TOWN COUNCIL REGULAR MEETING

Change Order No.

Date of Issuance: 9/22/2025
Owner: Town of Bristol
Contractor: Phoenix Fabricators, LLC
Engineer: Jones Petrie Rafinski Corp.
Project: Town of Bristol Water System Improvements

Bristol Water Improvements Contract B
Change Order 1
September 22, 2025

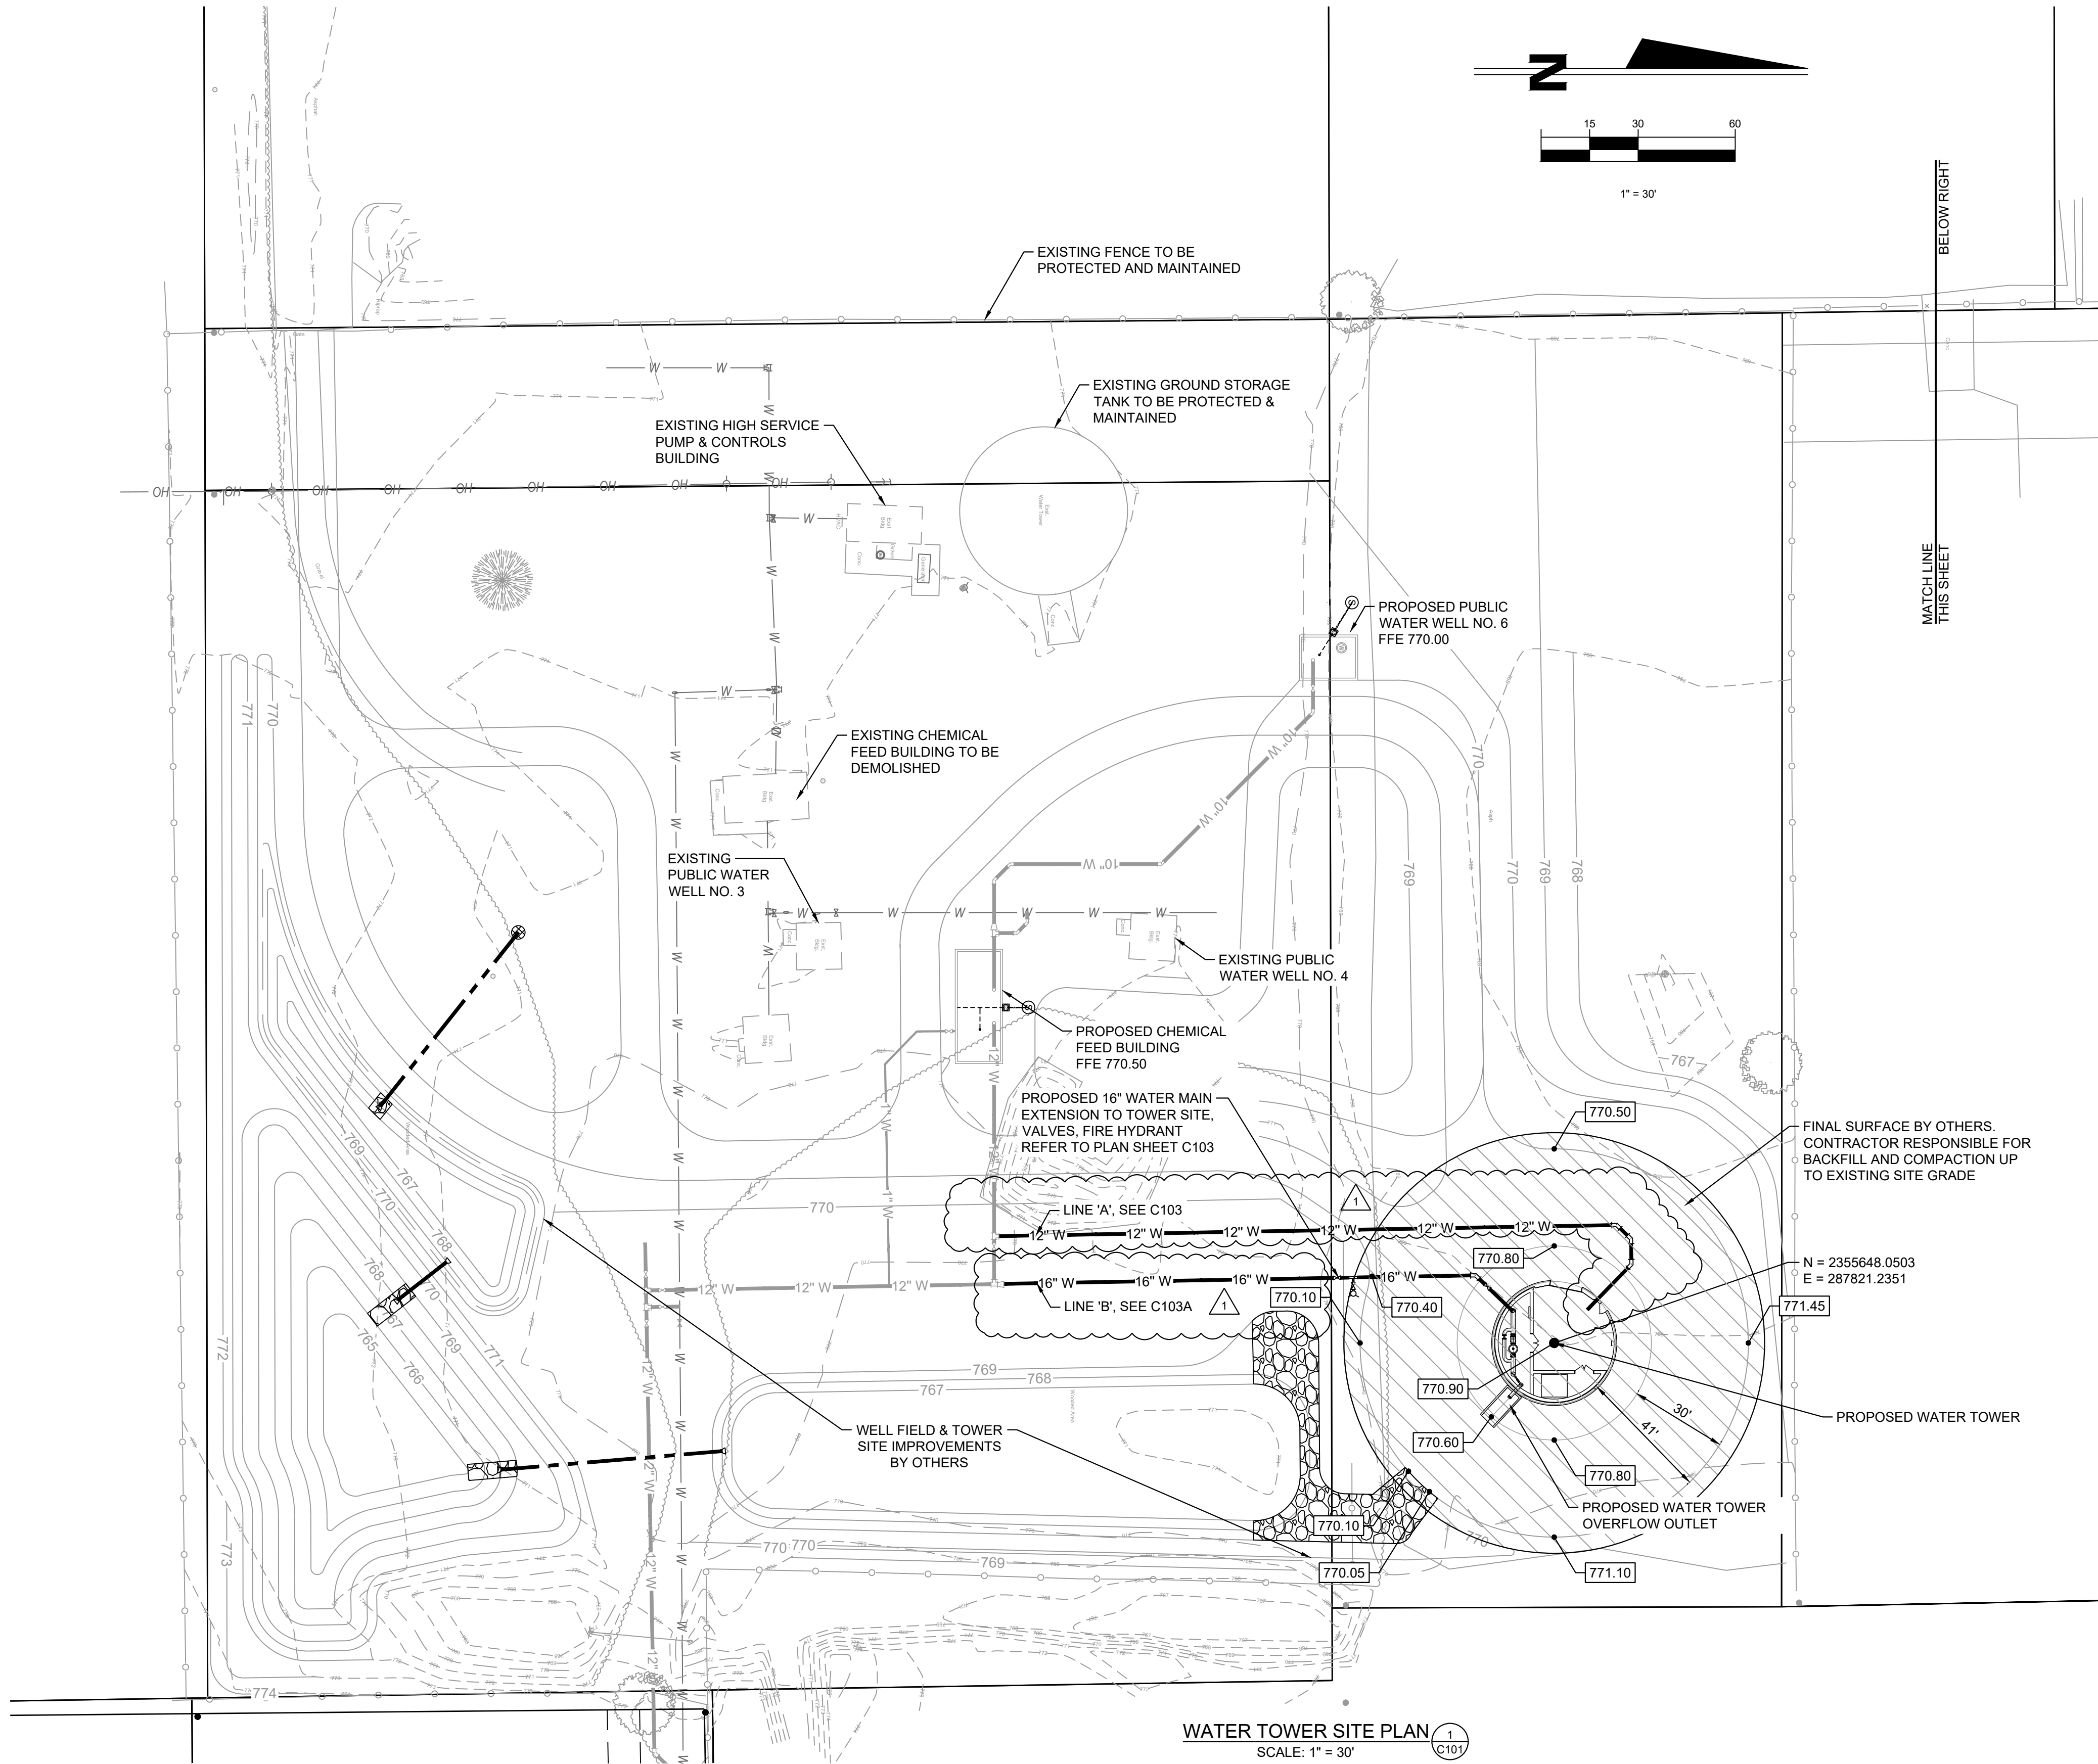
Due to the new well and increased capacity from this well field, IDEM requested an increase to the log-4 disinfection time. As the Town does not have a Treatment Plant and Clearwell to satisfy this requirement it was proposed to use the elevated tank to serve as a chlorine contact tank to meet the requirements of disinfection. This scope includes an additional pipe to serve as the inlet. This pipe is C900 pipe in the yard from the effluent pipe from the chemical building as shown on C101 and C103A. The pipe is DIP when under the Tower and SS pipe up to the tank above, shown on M102. The new pipe will have fittings and instruments as shown on M102. A tank level instrument will be added to the top of the tank to serve as a high-high alarm and shall turn off all pumps just before the tank reaches the high level overflow depth.

1. Level Monitoring on Top of the Tank, LIT-TANK

- a. LIT Rosemount 5408, or equal, flanged, with local display and 4-20mA output.
- b. Tank Manufacturer to include a port with flange on the top of the tank within the handrail.

WATER TOWER SITE PLAN
SCALE: 1" = 30'

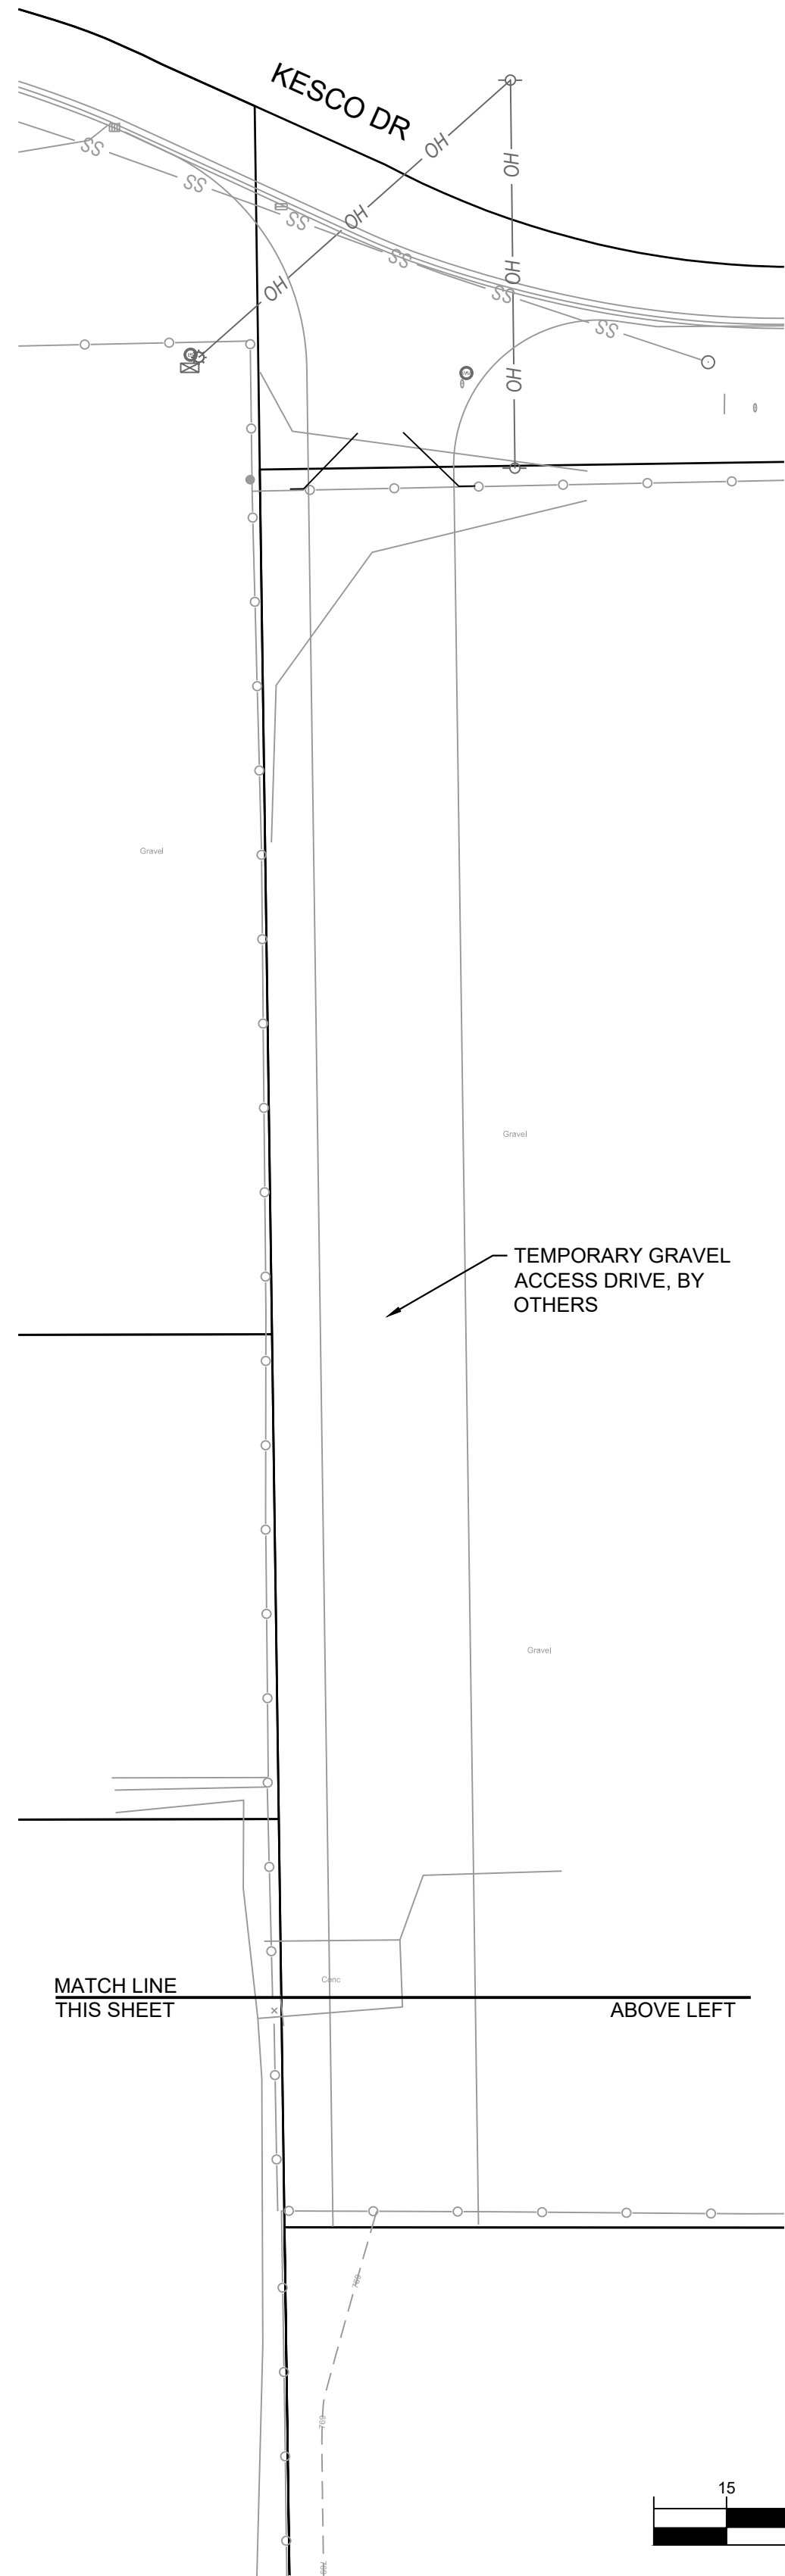
Updates: C101, C103, M104

File: J:\Projects\2023 Projects\2023-0005\07_Design\Engineering\Plans\Contract B - New 1 MG Elevated Water Tank\C103 - Line A Water Main.dwg Saved By:jfjlesong

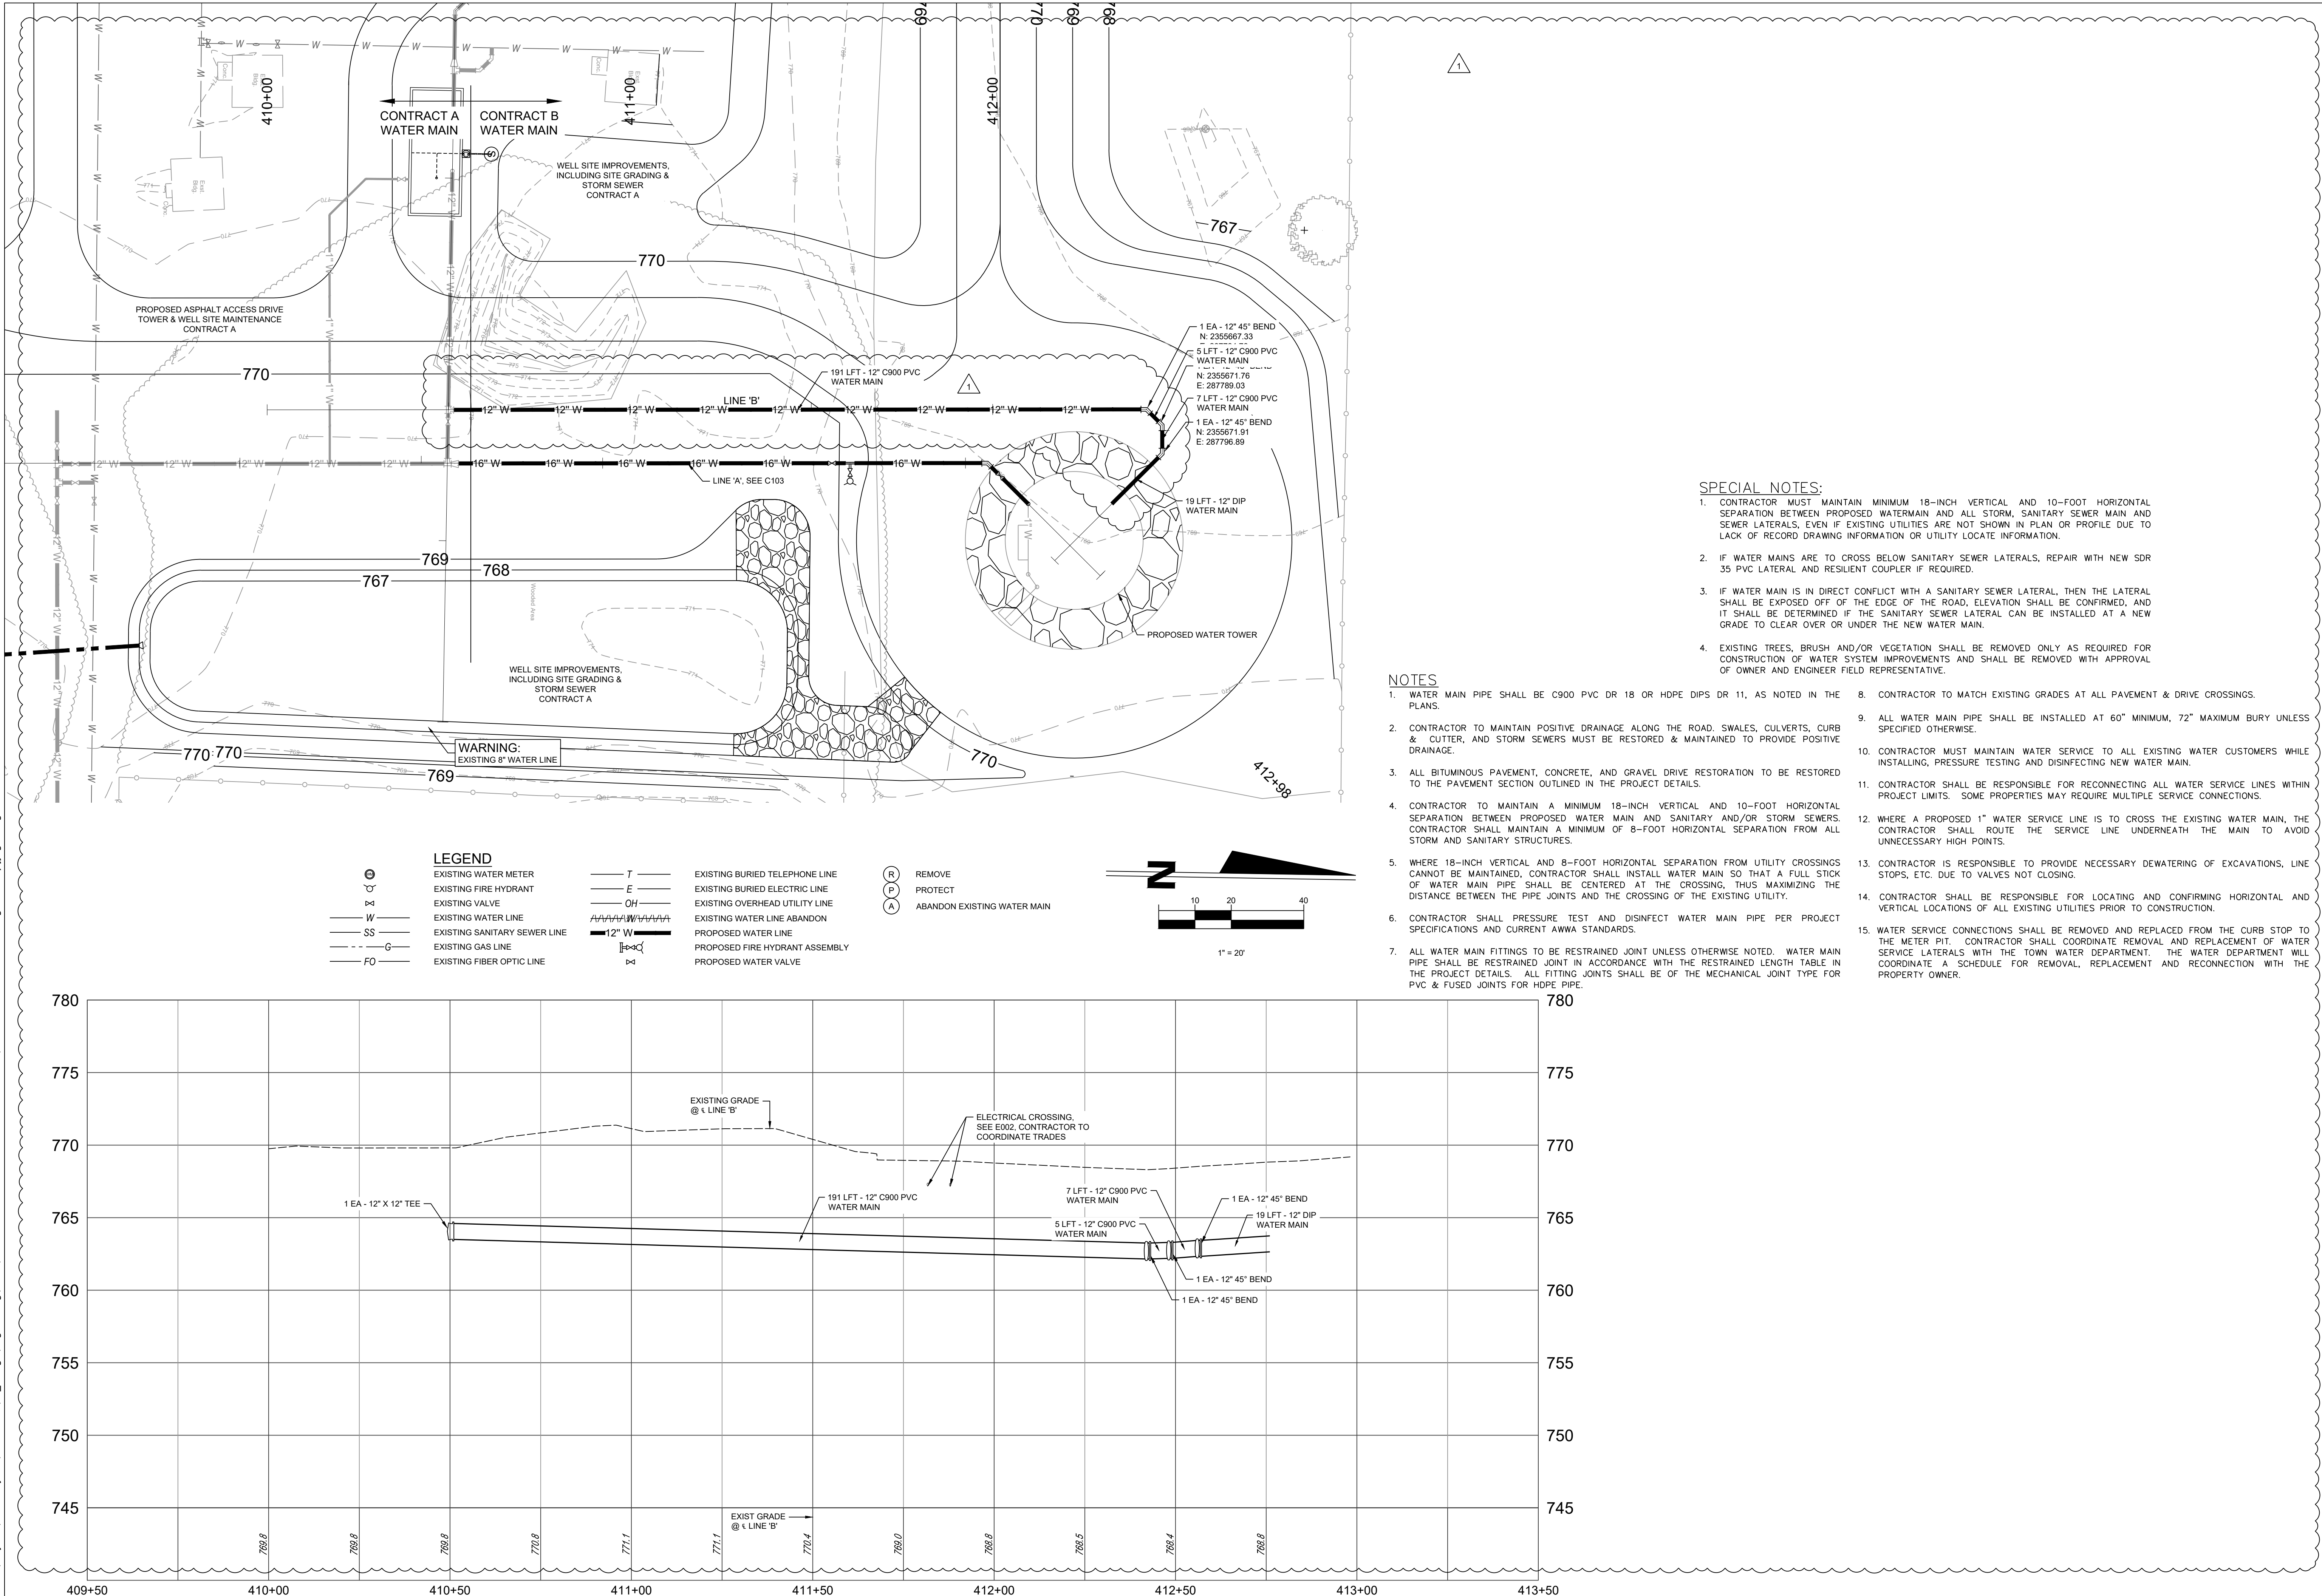
Credit: C103: 10 LF and 2 45s in yard due to the pipe alignment change
